Access Compliance Report

Public Rights-of-Way

(Pedestrian Signals)

Intersection ID: N/A	Main Street:	Cross Street: N/A	Location: N/A
ADA ID: 13E453BF1D68	Signal Type: One Push Button-Non APS	Overall Compliance: No	Severity Score: BTN 1: N/A BTN 2: N/A No BTN: N/A
Codes/Mitigation Info/Possible Solution		Field Measurements/Component Compliance

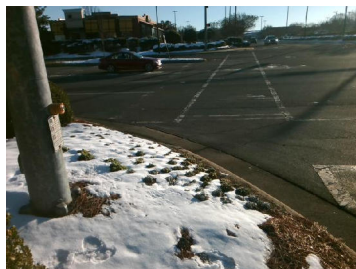
PROW/ADA: TMUTCD 4e.08, R404.3, R404.1, R404.7.1, R404.7.2

Compliance	Description	Data	Compliance	Description	Data
	Button Count	Button1	N/A	Distant to Additional Button (in)	N/A
	Additional Button Present?	No		Additional Button ID	N/A
N/A	Signal Buttons Required?	N/A	N/A	Additional Ped Posts Required	N/A
	How Many Ped Street Xings?	N/A		Located In An Island/Median?	N/A
N/A	B 1 Sign Present?	Yes	N/A	B 2 Sign Present?	N/A
Yes	B 1 Sign Purpose?	Yes	N/A	B 2 Sign Purpose?	N/A
Yes	B 1 Sign Lettering & Contrast?	Yes	N/A	B 2 Sign Lettering & Contrast?	N/A
Yes	B 1 Parallel To XWalk?	Yes	N/A	B 2 Parallel To XWalk?	N/A
No	B 1 PAR to Button?	No	N/A	B 2 PAR to Button?	N/A
No	B 1 PAR to XWalk?	No	N/A	B 2 PAR to XWalk?	N/A
No	B 1 Clear Floor Space?	No	N/A	B 2 Clear Floor Space?	N/A
No	B 1 FWD Approach?	No	N/A	B 2 FWD Approach?	N/A
N/A	B 1 FWD Approach Constrained?	N/A	N/A	B 2 FWD Approach Constrained?	N/A
N/A	B 1 FWD Approach Reach (in)	85.0	N/A	B 2 FWD Approach Reach (in)	N/A

N/A	B 1 FWD Approach Width (in)	N/A	N/A	B 2 FWD Approach Width (in)	N/A
N/A	B 1 FWD Approach Obstruction?	No	N/A	B 2 FWD Approach Obstruction?	N/A
N/A	B 1 FWD Approach Obstruction Dist (in)	N/A	N/A	B 2 FWD Approach ObstructionDist (in)	N/A
No	B 1 PARA Approach?	No	N/A	B 2 PARA Approach?	N/A
N/A	B 1 PARA Approach Constrained?	N/A	N/A	B 2 PARA Approach Constrained?	N/A
N/A	B 1 PARA Approach Reach (in)	85.0	N/A	B 2 PARA Approach Reach (in)	N/A
N/A	B 1 PARA Approach Width (in)	N/A	N/A	B 2 PARA Approach Width (in)	N/A
N/A	B 1 PARA Approach Obstruction?	No	N/A	B 2 PARA Approach Obstruction?	N/A
N/A	B 1 PARA Approach Obstruction Dist (in)	N/A	N/A	B 2 PARA Approach ObstructionDist (in)	N/A
N/A	B 1 Clear Floor Space Slope (%)	N/A	N/A	B 2 Clear Floor Space Slope (%)	N/A
N/A	B 1 Clear Floor Space XSlope (%)	N/A	N/A	B 2 Clear Floor Space XSlope (%)	N/A
N/A	B 1 PAR Slope (%)	N/A	N/A	B 2 PAR Slope (%)	N/A
Yes	B 1 Height (in)	34.0	N/A	B 2 Height (in)	N/A

N/A	B 1 Clear Xing Direction?	Yes	N/A	B 2 Clear Xing Direction?	N/A
	B 1 Crossing Direction	To E		B 2 Crossing Direction	N/A
Yes	B 1 DistanceTo XWalk (in)	0.0	N/A	B 2 DistanceTo XWalk (in)	N/A
No	B 1 DistanceTo Curb (in)	79.0	N/A	B 2 DistanceTo Curb (in)	N/A
Yes	B 1 Diameter (in)	2.0	N/A	B 2 Diameter (in)	N/A

Possible Solutions: Replace Signal Push Button With APS Button on New Post. Remove & Relocate Sign.
